Variant name: TE0803-03-4BI21-X

# Top View

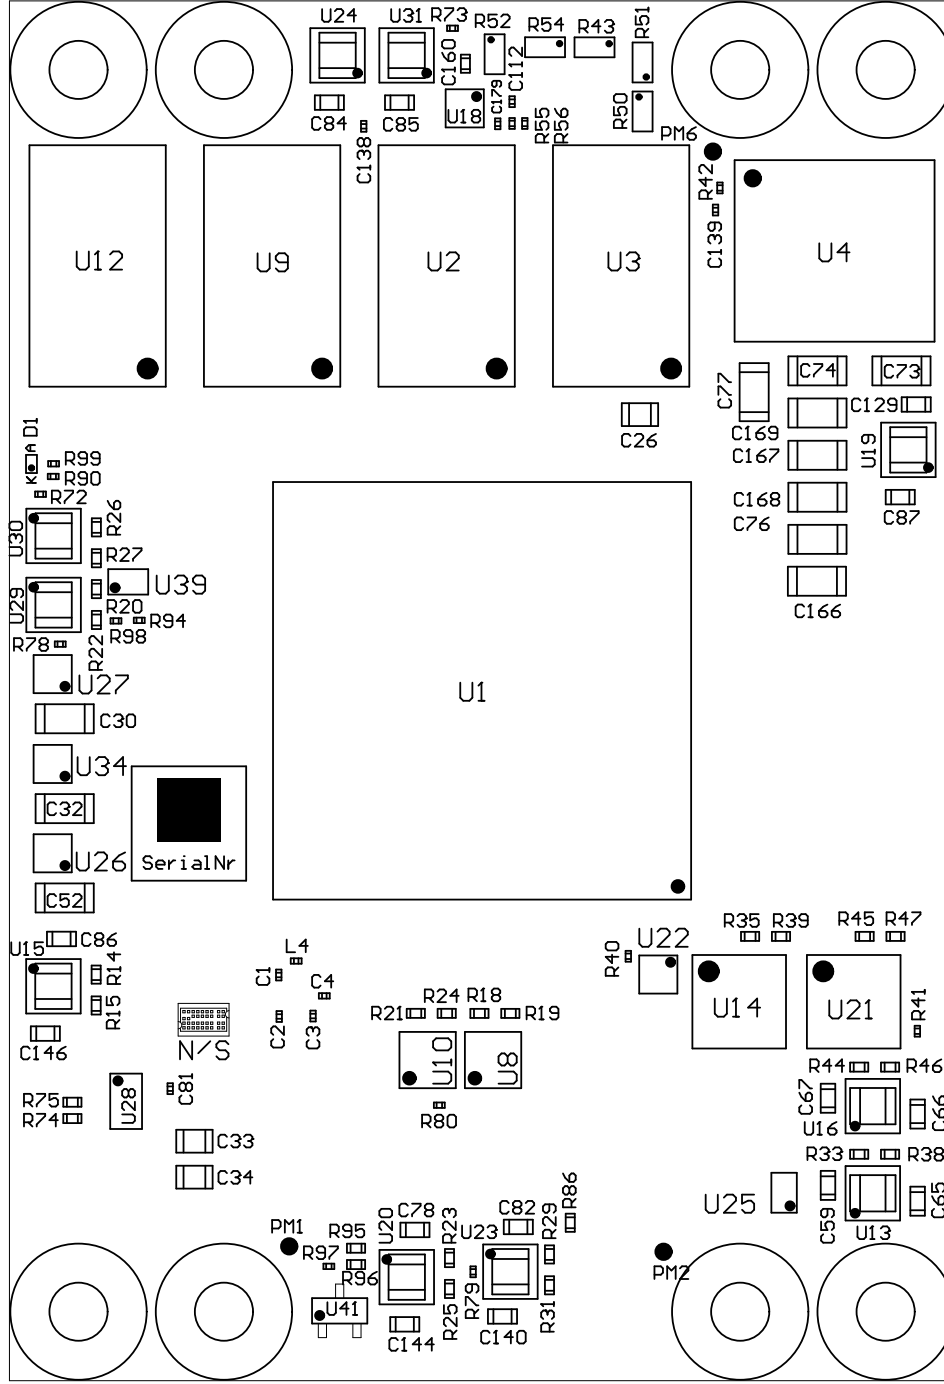
U41 Power supervisor TPS3106K33DBVR replaced  
Schottky diodes SBAS70-04LT1G
